**RC10
B6.2
TEAM KIT**

**RC10
B6.3
TEAM KIT**

RC10B6.2 vs. RC10B6.3 Comparison

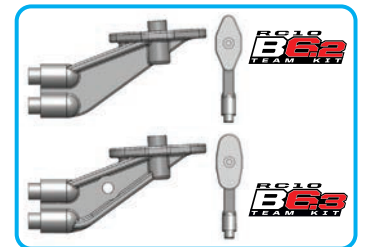
Octalock Spur and premium LCF material slipper pads (#90029 = 11mm ID, #90030 = 19mm ID)
